CERTIFICATE OF APPROPRIATENESS

Property: 321 Heights Boulevard, Lot 4 and Tract 5, Block 313, Houston Heights Subdivision. The property consists of two lots – Lot 4 is 7500 sq ft (50’ x 150’) and is developed only with a concrete parking pad. Tract 5 is 7450 sq ft corner lot containing a historic 2,751 square foot two-story wood frame single-family residence. The owner is proposing to build the new structure on Lot 4.

Proposal: New Construction – Construct a two-story 1,308 square foot residence and integrated two-car garage. A previously proposed, 2,536 square foot secondary structure was previously denied by the HAHC at the May 2015 meeting

321 Heights Boulevard – New Construction/Garage Resubmittal

EAST ELEVATION – FRONT FACING HEIGHTS BOULEVARD

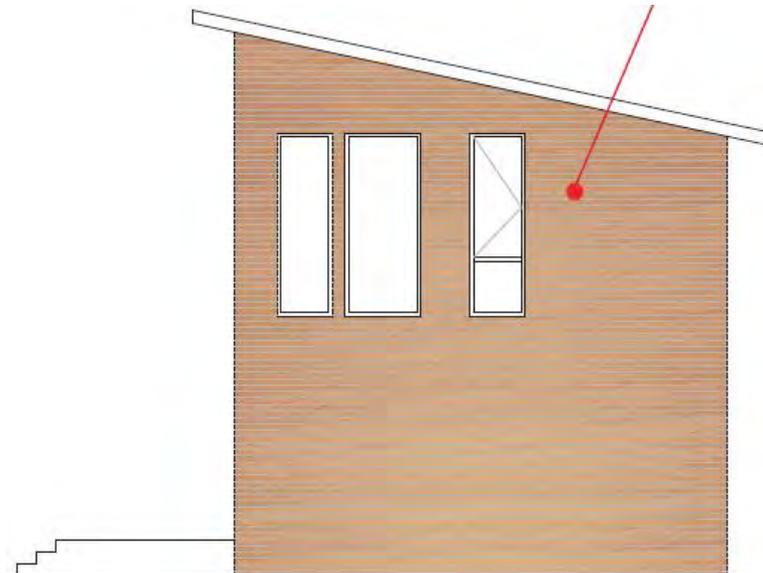
The front elevation of the proposed structure will have no fenestration on the first story. The second story will be comprised of three large vertical windows. The structure will be topped with a shed roof sloping down towards the northern property line. See drawings for more detail.

Does Not Meet Approval Criteria #2 – The exterior features of the proposed new construction are not compatible with the exterior features of existing contributing structures in the HSHD. An example of exterior features of existing contributing structures in the HSHD can be found on the adjacent contributing structure. These existing exterior features include: Triangular bordered front gable, covered front porch with round full-height columns, triple bay double hung one-over-one windows, foundation banding and fascia banding on a one-story structure. The proposed structure includes cedar lap siding and fixed pane windows, neither of which are typical exterior features of existing contributing structures in the HSHD.

SITE PLAN
DENIED MAY 2015

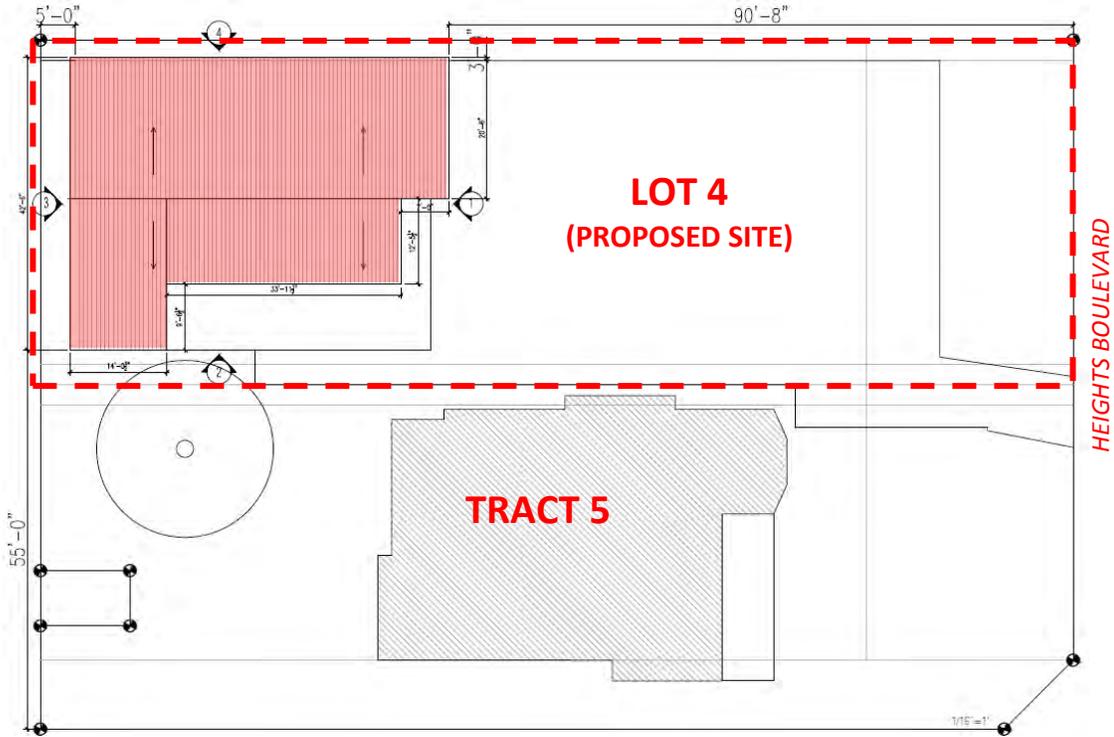
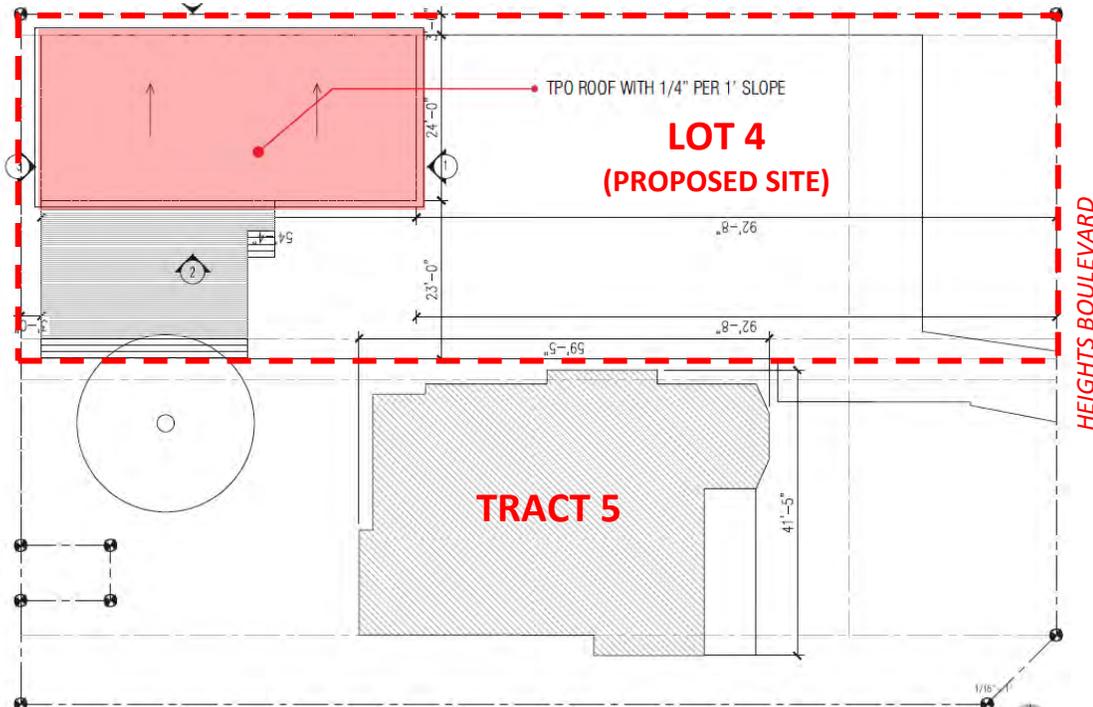
Does Not Meet Approval Criteria #1 - The proposed new construction does not match the typical setbacks of existing contributing structures in the historic district. The new construction is proposed to be placed 92.8 feet from the front property line. This is significantly greater than the typical front setback line within the HSHD. In fact, the adjacent contributing structure is significantly closer to the front setback line than the distance proposed for the new construction. Greater setback lines along Heights Boulevard would substantially reduce the historic character of the HSHD. The proposed construction should be placed approximately in line with the existing adjacent contributing structure.

ROOF PLAN
DENIED MAY 2015

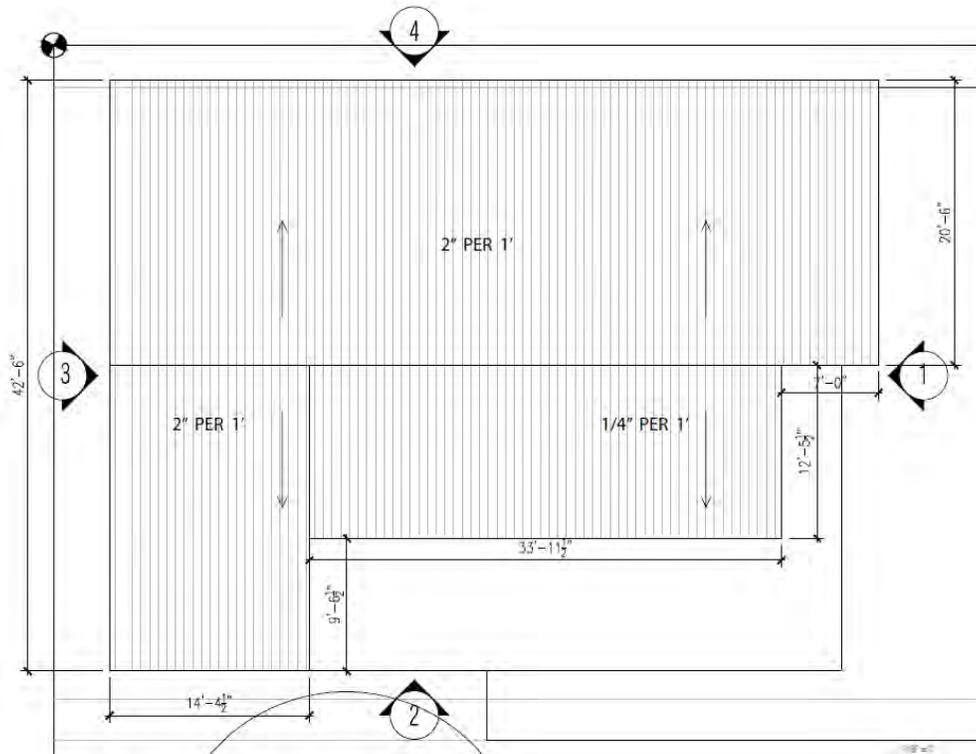
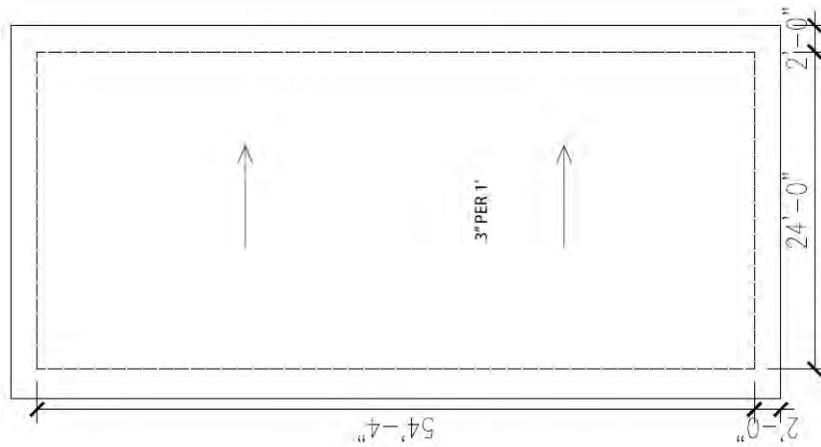
Does Not Meet Approval Criteria #3 – The roofline of the proposed new construction is a basically flat, minimum slope membrane roof which is not compatible with rooflines and resulting typical proportions of existing contributing structures in the HSHD which generally have sloped roofs in the 5:12 or 6:12 angle proportion. A typical example would be the adjacent existing contributing structure which has a sloped roof that is typically found in the HSHD.
